GROWTH MANAGEMENT DEPARTMENT STAFF REPORT
PONTE VEDRA OVERLAY DISTRICT
May 1, 2024 Special Public Meeting
ARC 2024-04 Golf Club Patio Renovation (Ponte Vedra Inn & Club)

To: Architectural Review Committee
Staff: Amanda Rose, Senior Planner | Brandon Tirado, Planner
Date: April 22, 2024

Summary of Request: Applicant is requesting design approval to remove an existing wooden pergola and renovate the exterior of the Golf Club Patio. Proposed changes include 1,200 square feet of concrete pavers and other impervious surfaces, construction of an outdoor fireplace, renovations to the existing wood deck, and installation of new landscaping, irrigation, and one (1) new exterior door, located at 35 Pablo Dr. within the Ponte Vedra Inn and Club. Lighting updates are also proposed. The applicant is also requesting approval for a potential canopy fabric replacement (e.g. “add alternate”). The applicant has confirmed they will be providing physical color/material samples for the Board to review at the hearing.

Figure 2: Site Plan, as provided by the applicant.

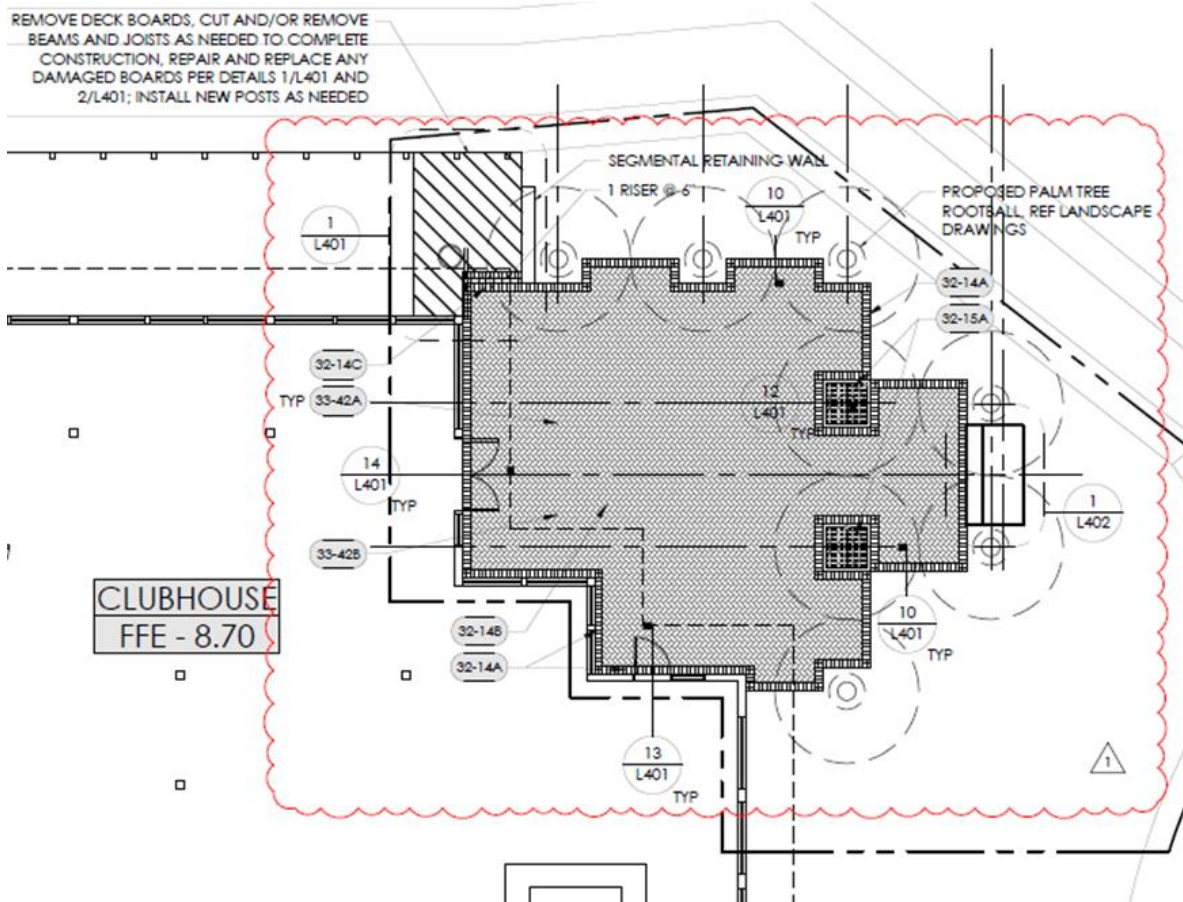
Staff Review—Planning Division: Please refer to the submitted Site Plan, Existing Conditions Photographs, Materials, Landscape Plan, and Photometric Plan, provided below within Figures 2, 3A-B, 4A-C, 5A-B, 6A-B, 7A-B, and 8, along with corresponding staff comments.

Figure 6A-B: Landscape Plan + Plant Schedule, as provided by the applicant.

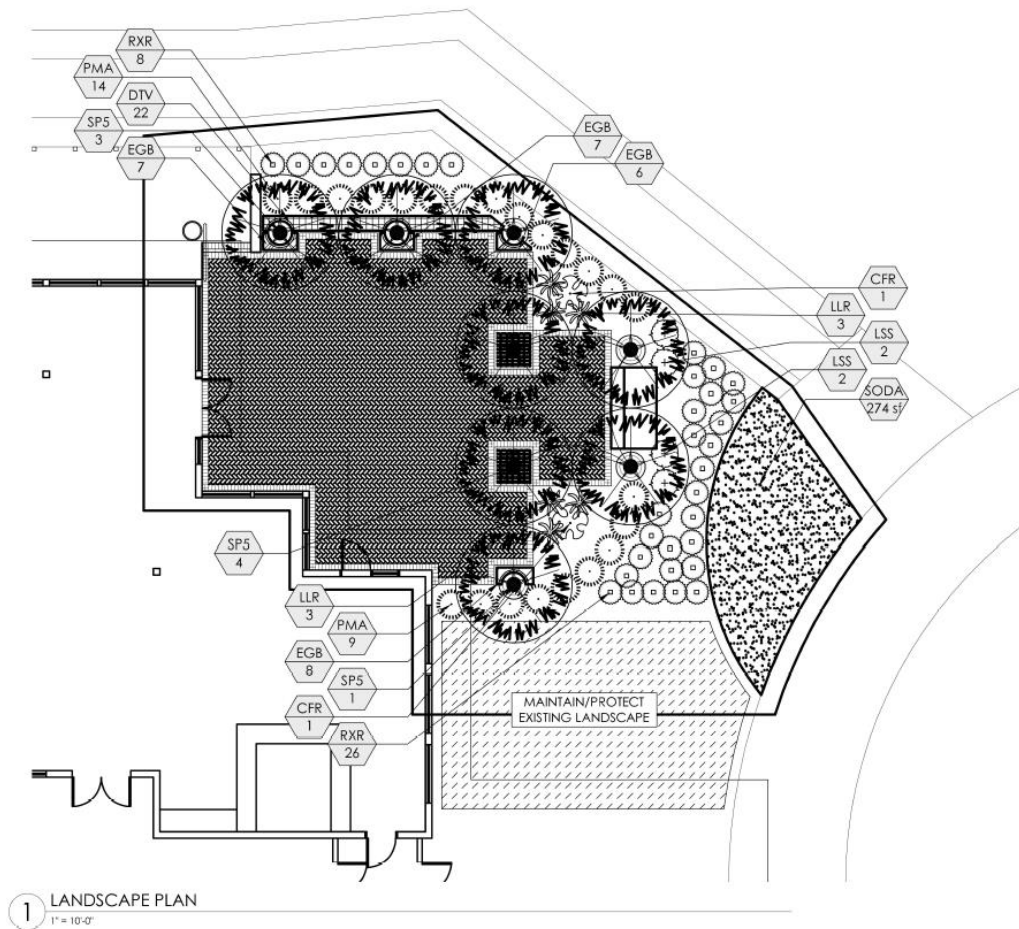
***Landscape Plan (see Figures 6A-B)**—The proposed Landscape Plan appears to be consistent with PVZDR Section VIII.Q.5(e). Design Elements and Materials of the PVZDR. Per PVZDR Section VIII.Q.5.e(8), the ARC may require utilization of particular landscape and plant species where a pattern of vegetation has been established or where such species are determined to be desired.

Figure 7A-B: Electrical Fixture Plan + Proposed Light Fixtures, as provided by applicant.

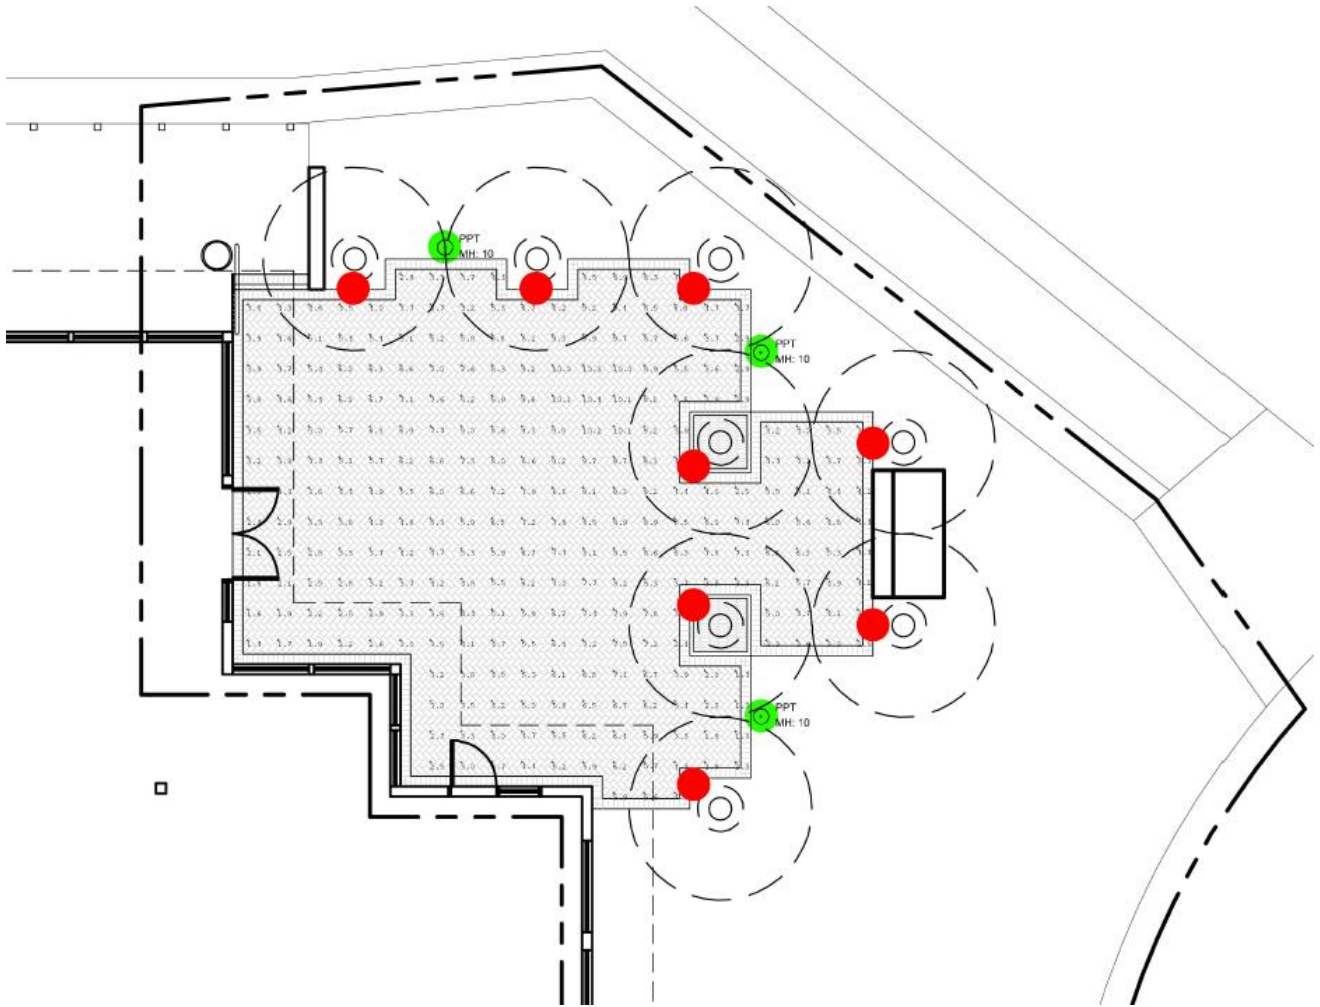
***Photometric Plan (see Figures 7A-B)**—Per PVZDR Section VIII.Q.5.e(9), architectural lighting shall be recessed under roof overhangs or generated from a concealed light source or low-level light fixtures. Site lighting shall be of low intensity, shall be white light which does not distort colors and shall not spill over into adjoining properties, roadways, or in any way interfere with the vision of oncoming traffic.

The applicant notes that the proposed fixtures are designed to focus light onto the patio and to reduce glare from neighboring properties. The applicant states that the photometric plan shows lighting levels as high as 10 foot-candles but that the fixture selected allows for either a manual adjustment to lower output or to utilize a dimmer switch. Please also note that the applicant has indicated to Staff that festoon lighting has been removed from the proposal.

Staff has concerns about the Photometric Plan, as it does not demonstrate fully how the proposed lighting affects the adjacent right-of-way, specifically at the roadway. Staff has asked that the applicant provide additional information on the photometric levels near the property lines, as well as information about the light color/s.

Figures 5A-B: Patio Paver Design, as provided by the applicant.

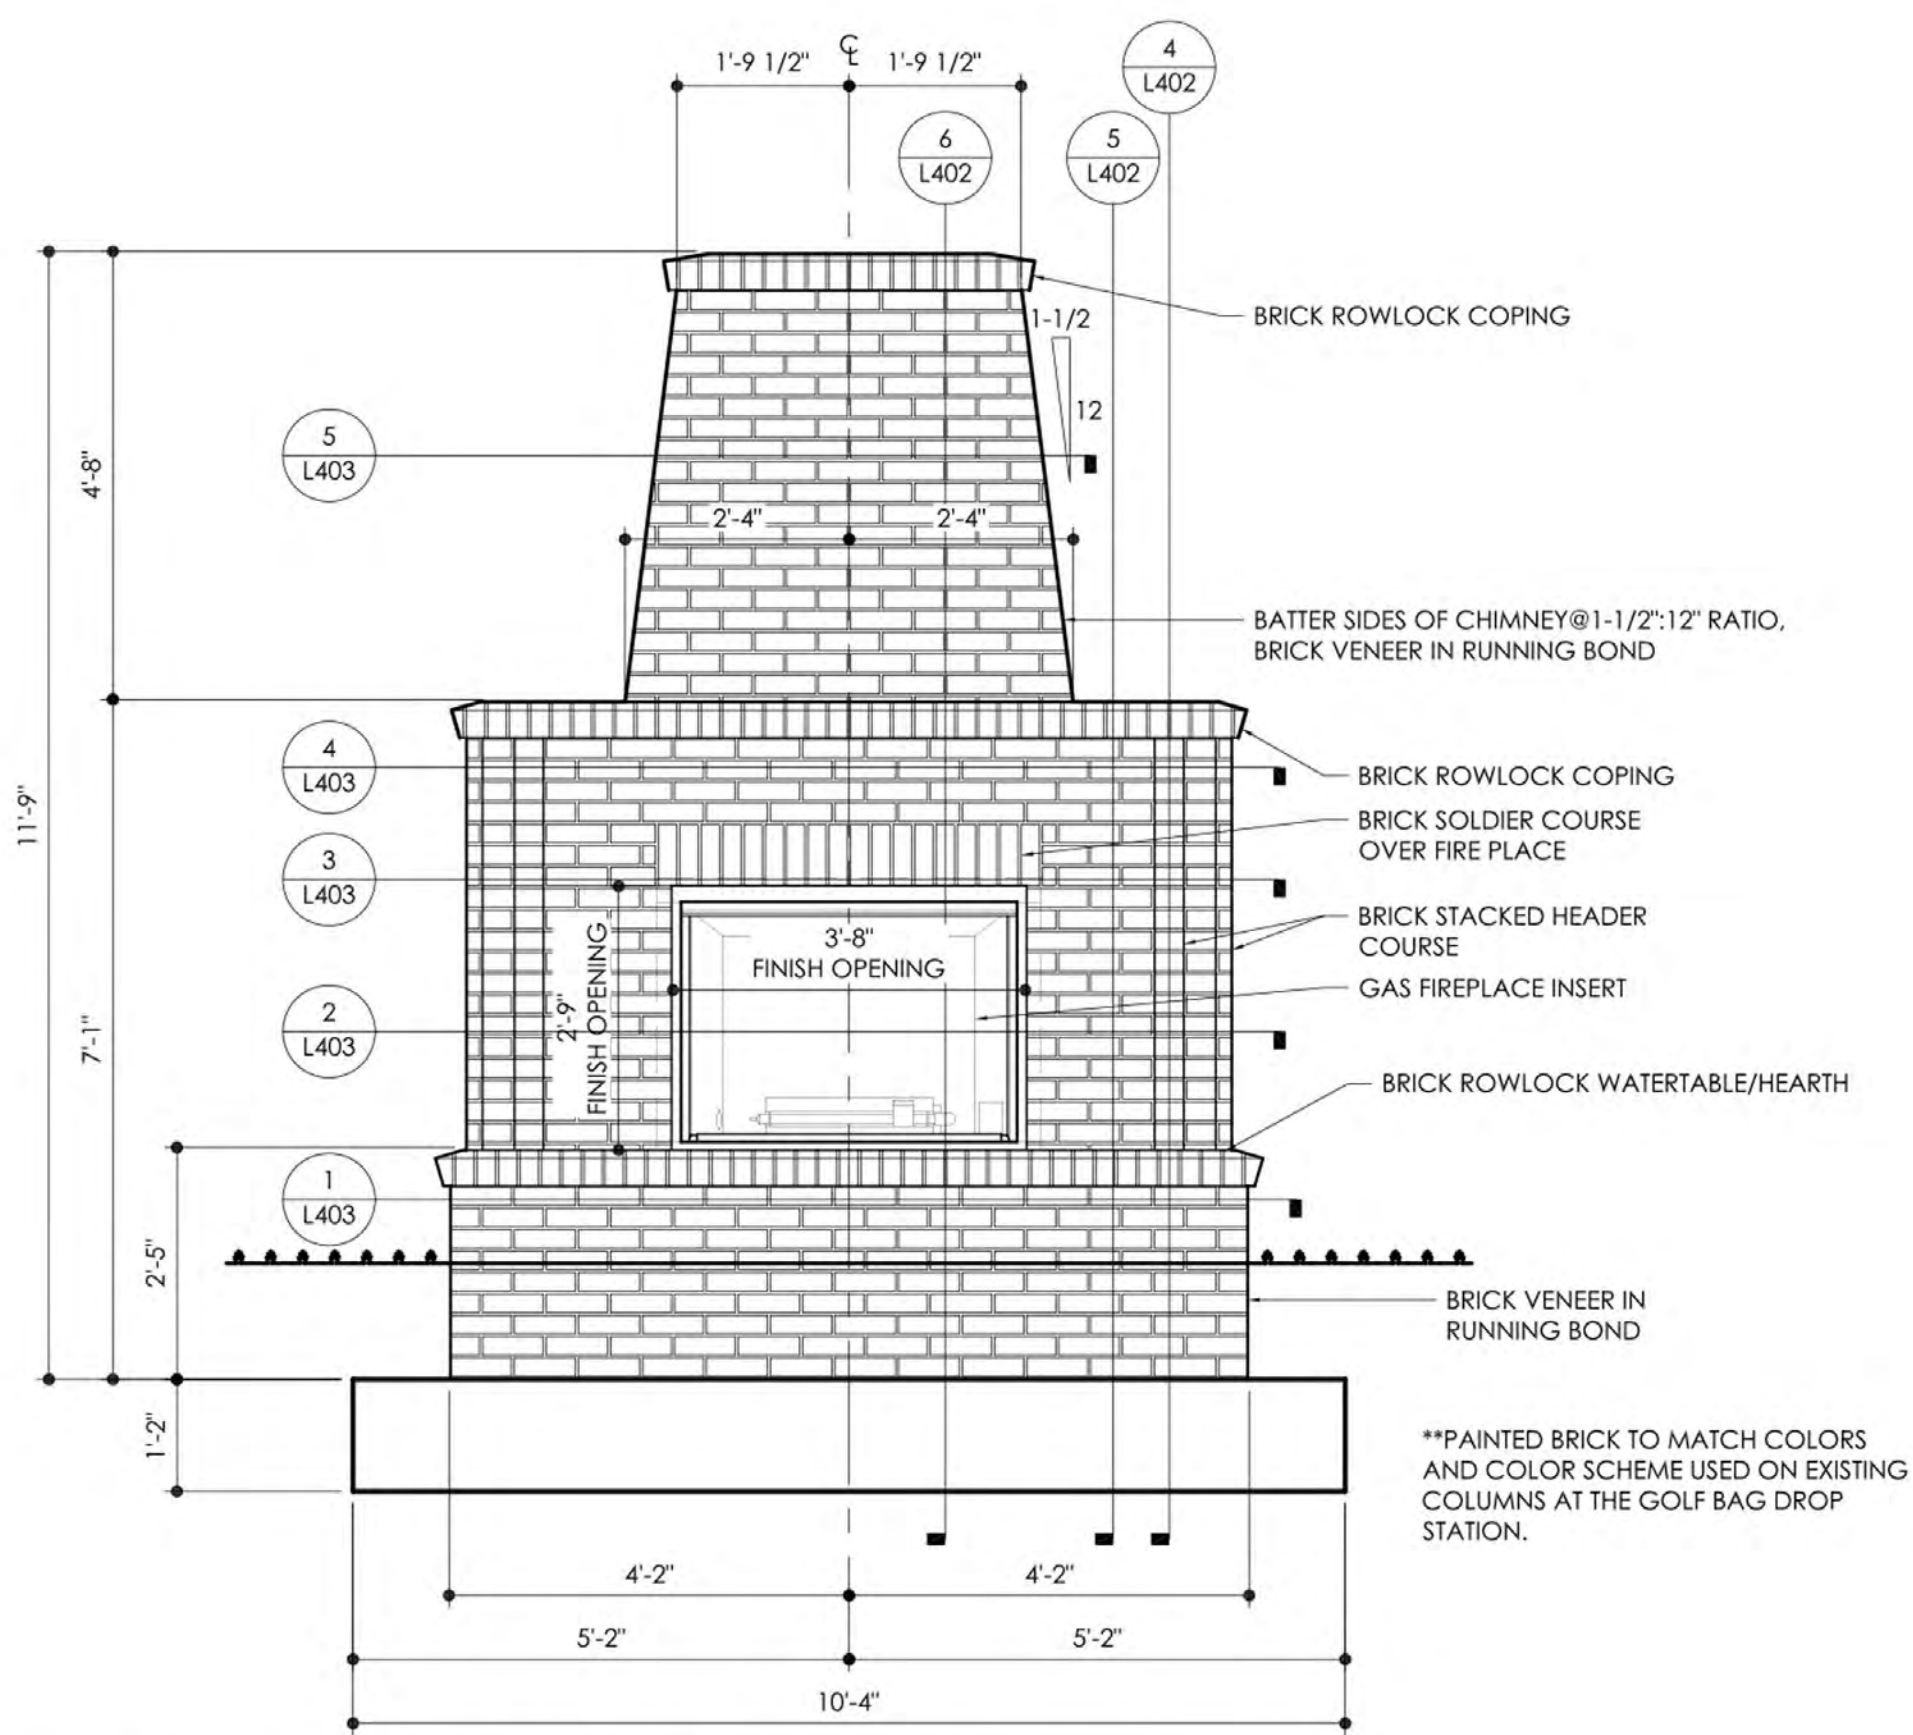
***Patio Pavers (see Figures 5A-B)**—The colors and material of the proposed paver area appear to be consistent with PVZDR Section VIII.Q.5(e). Design Elements and Materials of the PVZDR. The proposed design and color appear subdued and in harmony with other locations within the Ponte Vedra Overlay District. The applicant notes that the proposed paver pattern and style matches that used at the Ocean Golf Course near the first tee.
